Re: PLM2021/0123- 53A Warriewood Rd, WARRIEWOOD

Design + Sustainability Advisory Panel Meeting Report – 27 May 2021

APPLICANTS RESPONSE

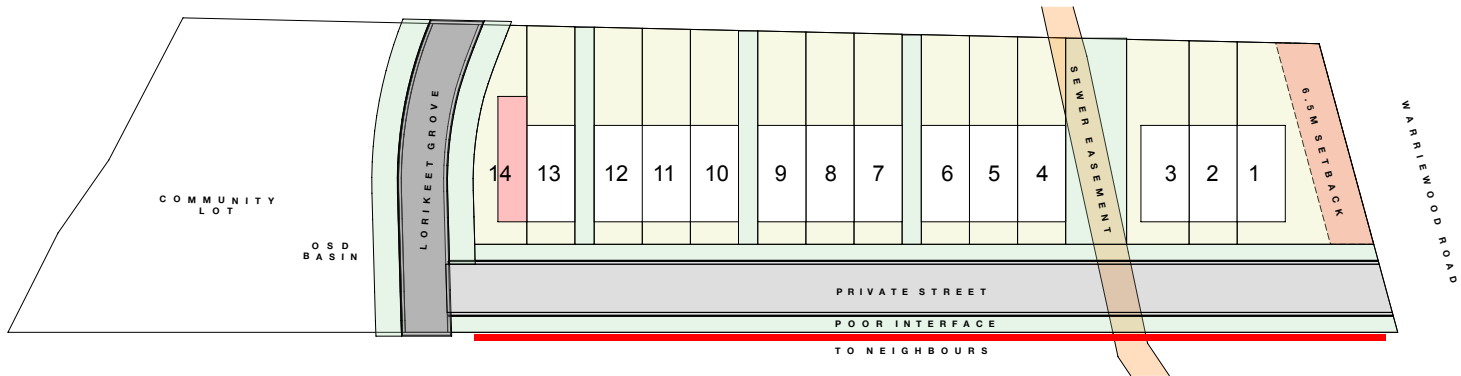
7. The Panel suggests other built form solutions be investigated on this sloping site to determine whether these alternatives might allow for a greater (and more equitable) distribution of sun to the living areas (both interior and exterior) of a greater number of dwellings. Could the comparatively longer and narrower parcelization of land that results from a row house configuration achieve this? Could an access road positioned along the eastern boundary also achieve this along with a more generous road width?

We have tested the DSAP proposal and found it to be lacking merit for the following reasons:

- a. In our Pre-Lodgement meeting of 18th February 2021, Council made it clear they did not support row-housing as suitable typology for this site.
- b. A one-sided street is an inefficient form of infrastructure. It also results in one side of the street fronting the back fences of the adjoining property which is a deleterious outcome for those neighbouring properties.
- c. the yield will not meet the minimum requirement of the DCP for this site, see image below.
- d. the narrow row houses will have poorer amenity than the proposal with less ventilation and light and will result in a bulkier built form outcome.
- e. the narrower north-western facade means each home provides less sun than the proposed homes on this flank, however it is acknowledged that each home will be equitably penalised.

See scheme above testing the outcome of an offset access road that does not meet the minimum yield for the site required in the DCP. This site is a remnant site with no opportunity for amalgamation, it is narrower than ideal and this does put some limitations on the development outcome that Council needs to consider when determining this proposal. The proposal still results in all lots achieving a soft landscaped area in excess of 30% with some of the lots achieving well in excess of 35%. The average soft landscaping ratio is very close to the DCP control requirement of 35%.
